D/DRC Case

2225 Park Street

DESIGN/DEVELOPMENT REVIEW COMMISSION
DESIGN REVIEW DISTRICT
HISTORIC AGENDA
EVALUATION SHEET
Case #5

NATURE OF REQUEST: Request for a Certificate of Design Approval for site improvements.

Existing conditions – Dotted line represents proposed height of trellis

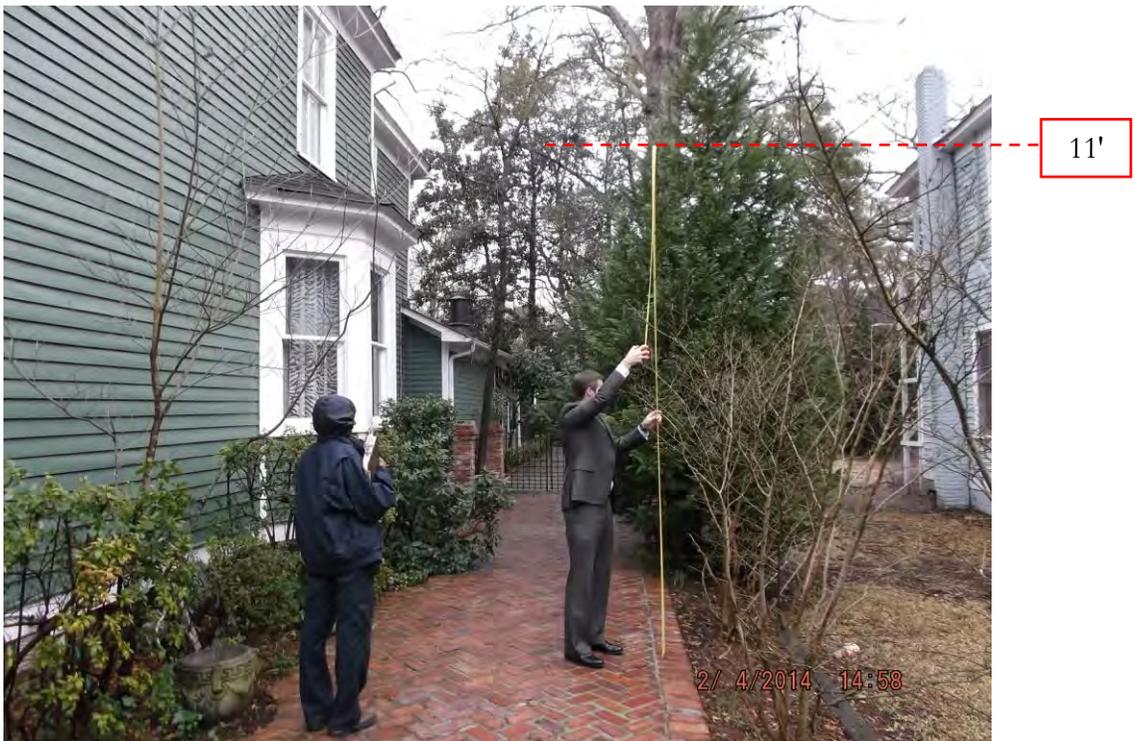
As proposed, the project is not sympathetic to the historic character of the Elmwood Park Architectural Conservation District and does not meet Zoning regulations for height. Staff recommends reducing the height of the trellis to a more compatible height, not to exceed seven feet. Alternatively, landscaping could be used in lieu of the trellis to provide a higher and denser privacy screen. The applicant has mentioned the potential use of Cypress trees if the trellis cannot be constructed as proposed. Planting trees or other landscaping for screening would not require design review.

The applicant's proposal for an 11' high wood trellis along the right side of the property line is 4' beyond the maximum height allowed by Zoning. Staff has recommended for the height to be reduced to 7' to be in compliance. The applicant has stated that 7' is not high enough to provide adequate screening.

Staff measuring height of proposed 11' trellis

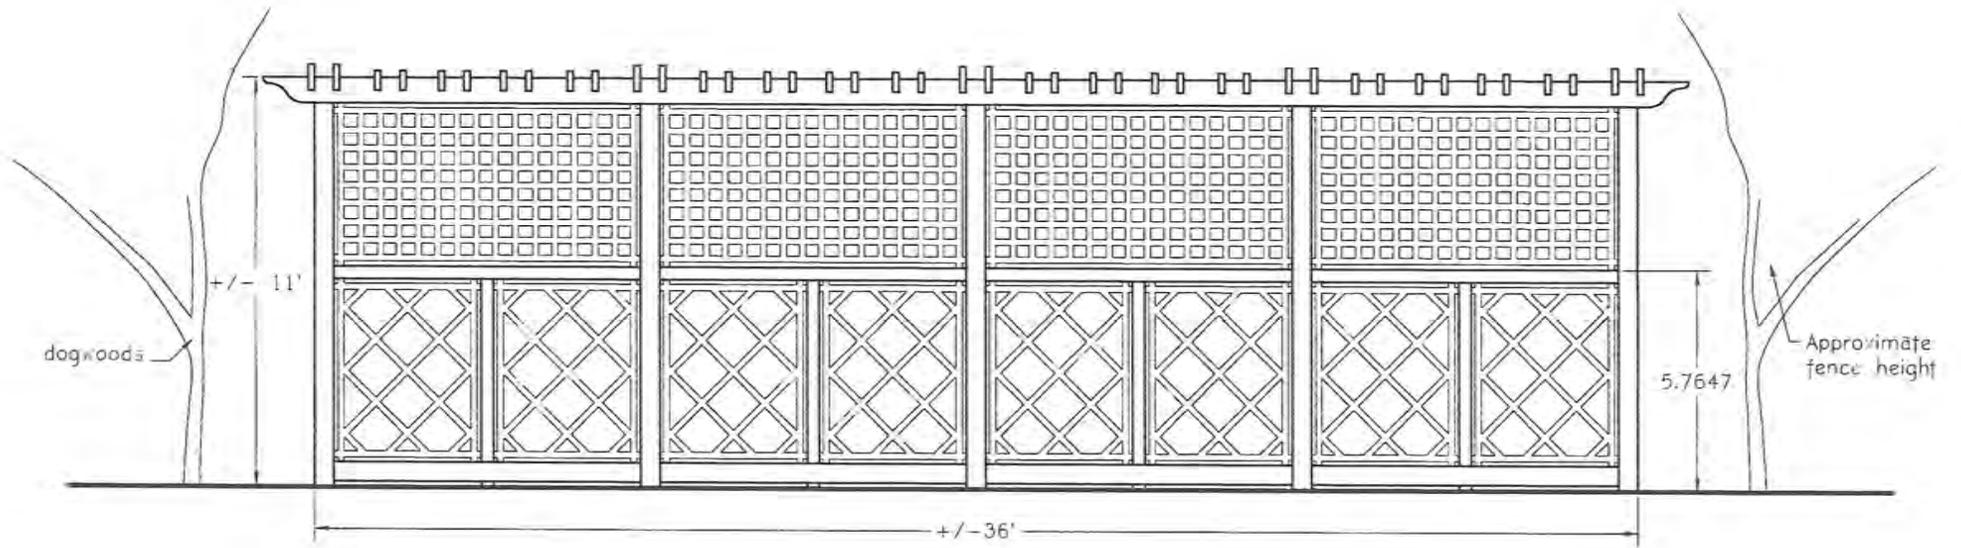
The applicant's proposal to install two 36' wide by 11' high wood trellis sections along the right side property line is not in keeping with the historic character of the district. There are a variety of fence types in Elmwood Park including combinations of wood, brick, and iron; however, there are no residential fences that approach the height of the proposed trellis. As drawn, the two sections combined would be approximately 80' long and just over 11' high. The proposal places the sections directly in front of an existing 6' wood privacy fence to create a very large privacy screen. Although decorative trellises can be found throughout the district, they are typically used as garden features or to frame a side yard gate. This proposal is much more elaborate and the sheer size places it in the screening wall/fence category instead of a simple garden trellis.

Rear view of 2225 Park Street from Aiken Street

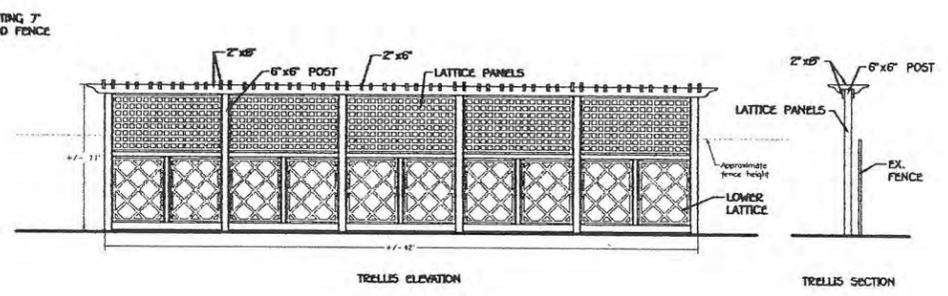
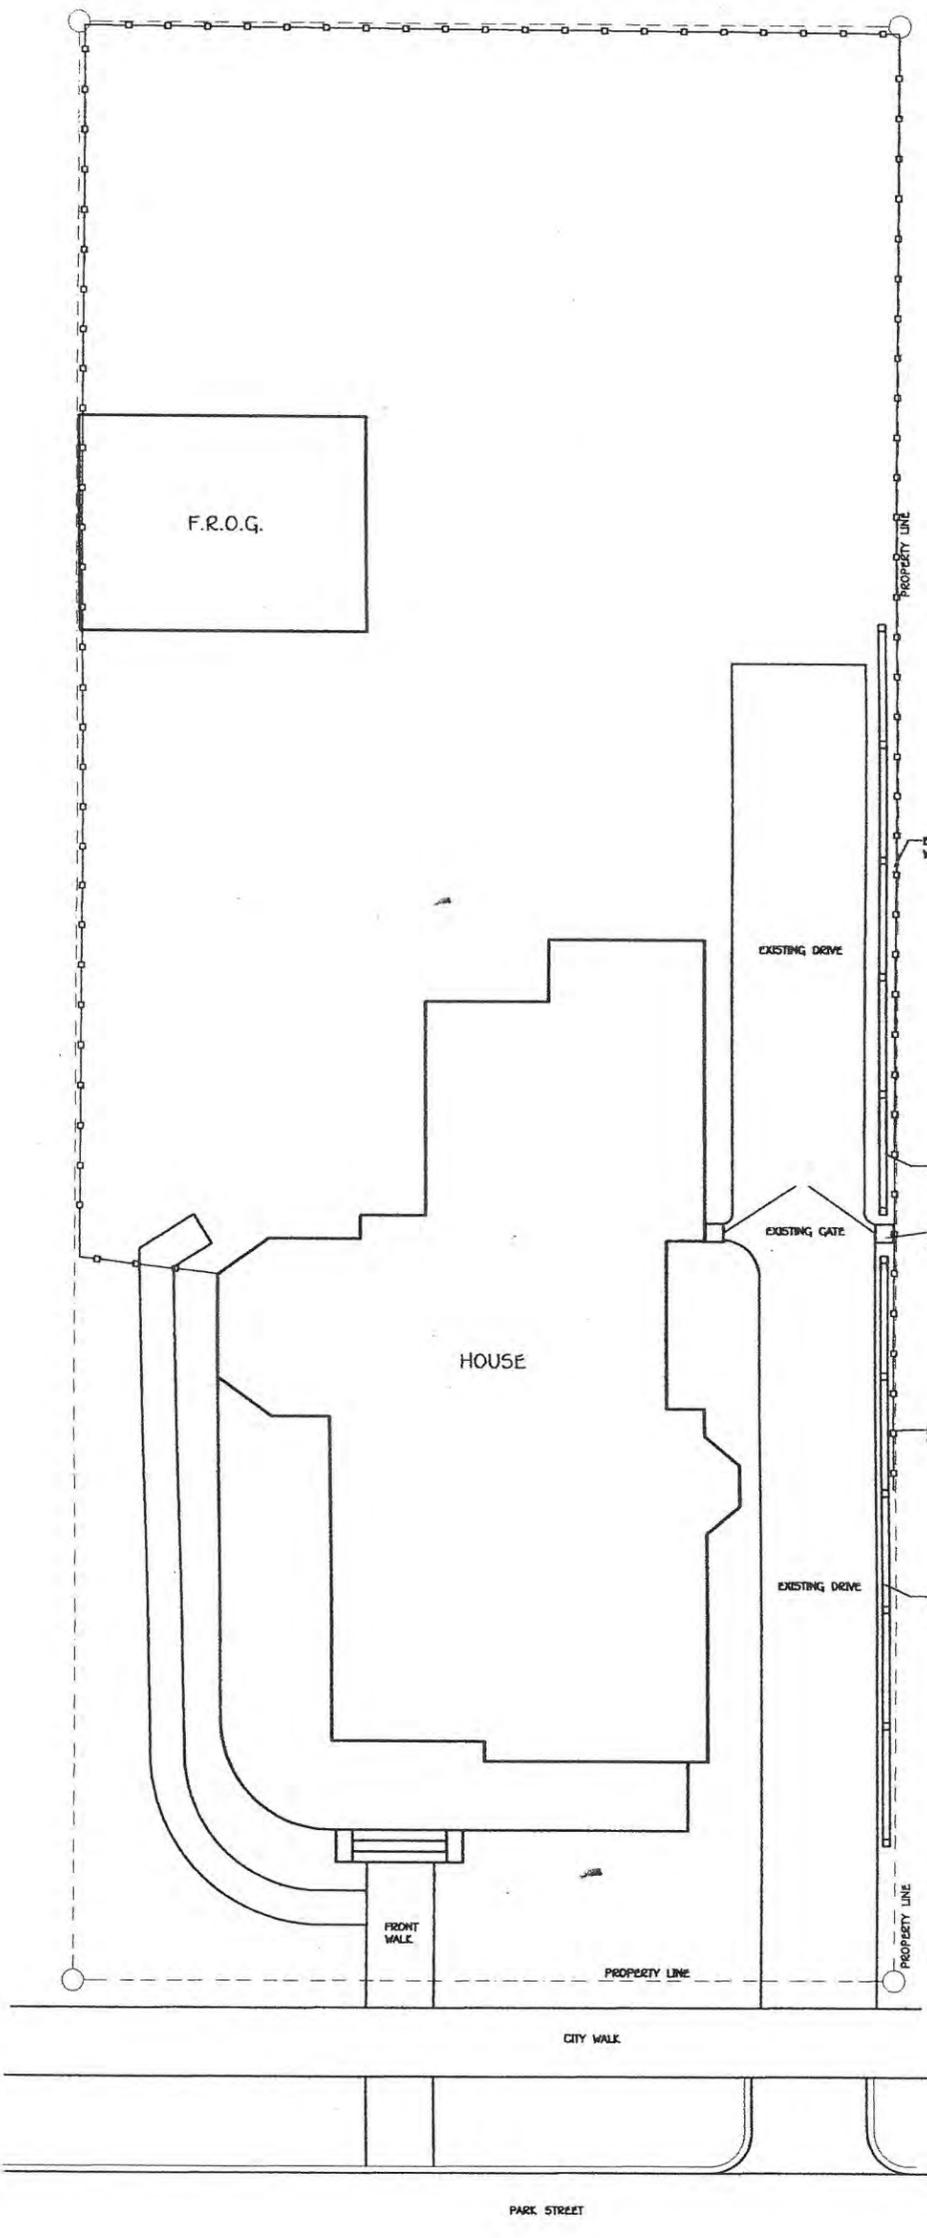
The front section of the proposed trellis would be very visible from the Park Street side of the public right-of-way. The rear section of the proposed trellis would not be as visible from the Park Street side; however, the upper portion would be highly visible from Aiken Street through the back yard of 2229 Park Street.

TRELLIS ELEVATION

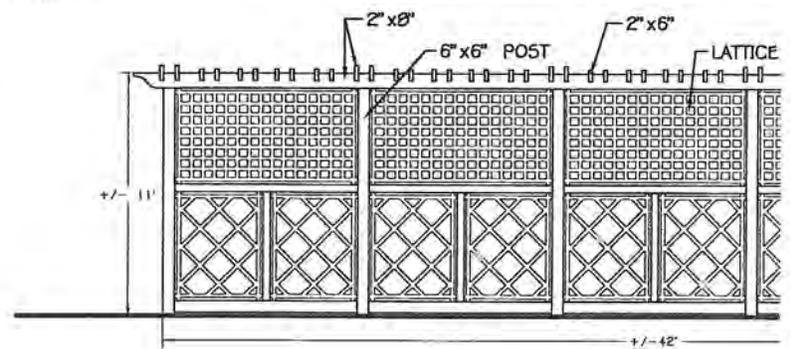
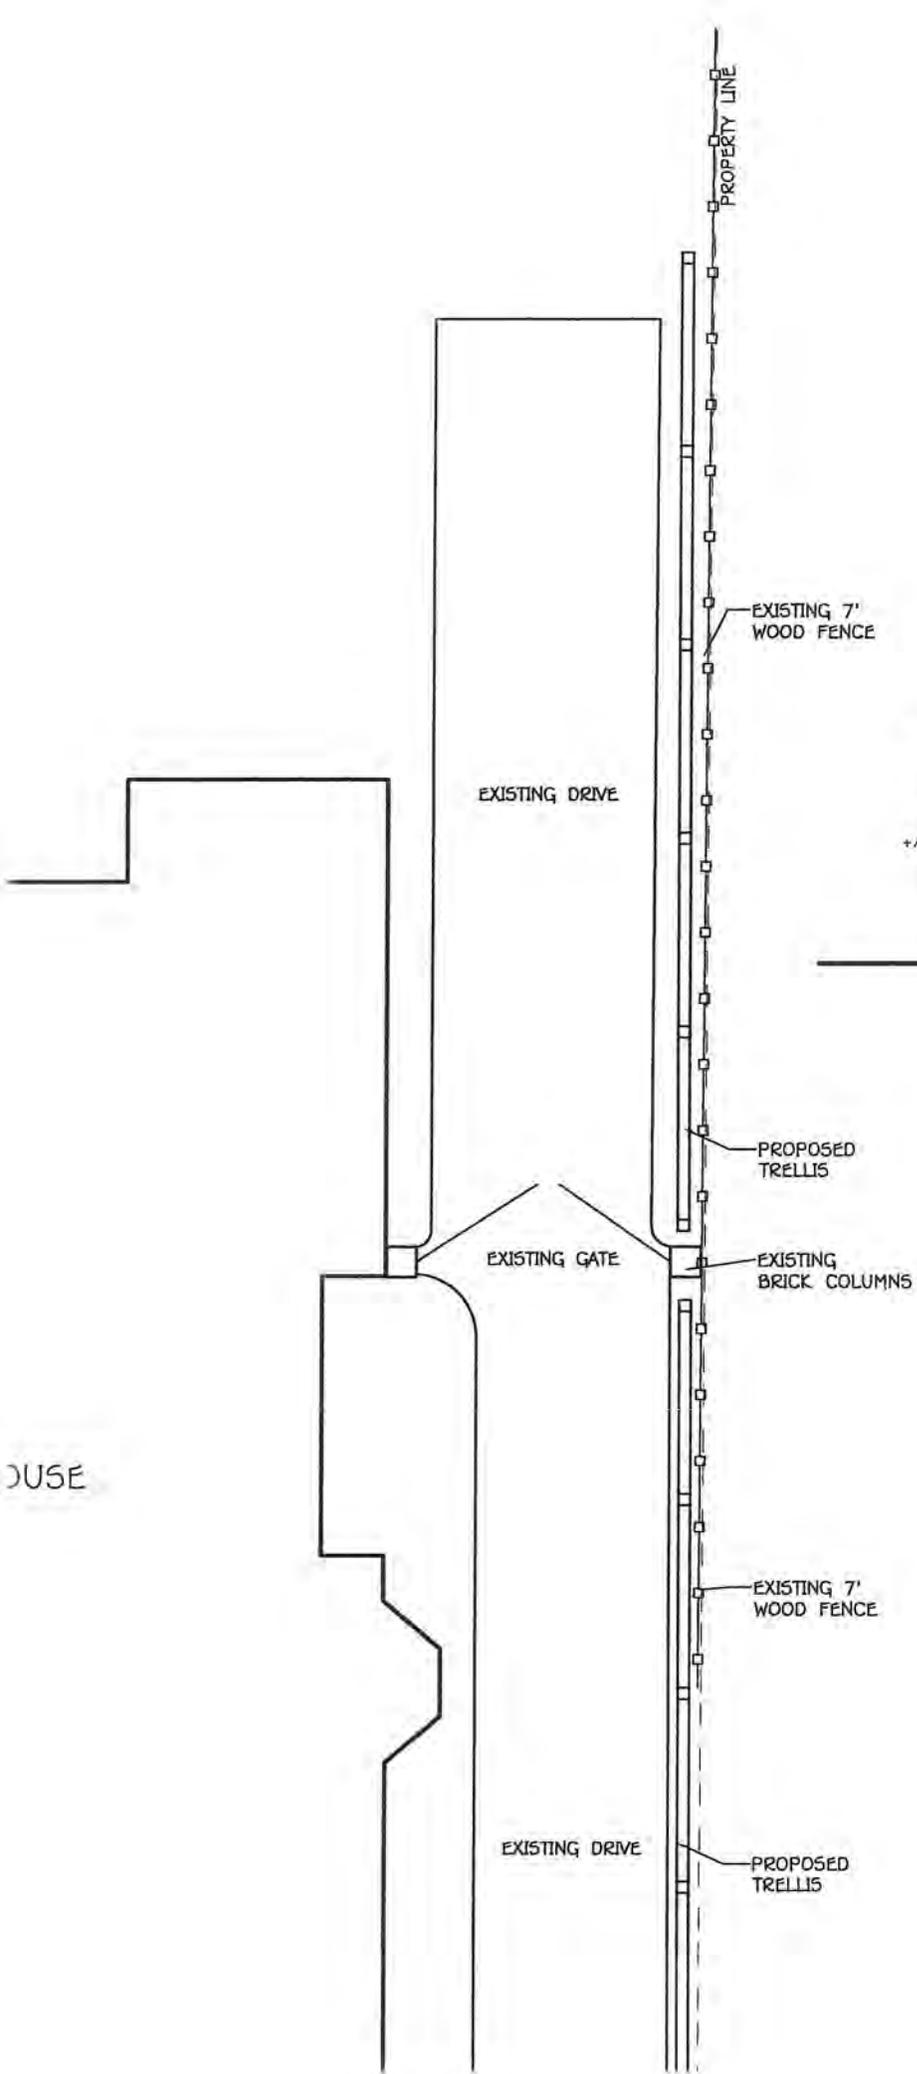
As stated above, seven feet is the maximum height allowed by Zoning, and no allowance for additional height shall permit any feature of any fence or wall to extend above seven feet high. The proposed trellis features decorative elements that extend beyond 11' as shown on the elevations. Staff recommends reducing the height of the trellis including the decorative elements on the top to a maximum of seven feet high.
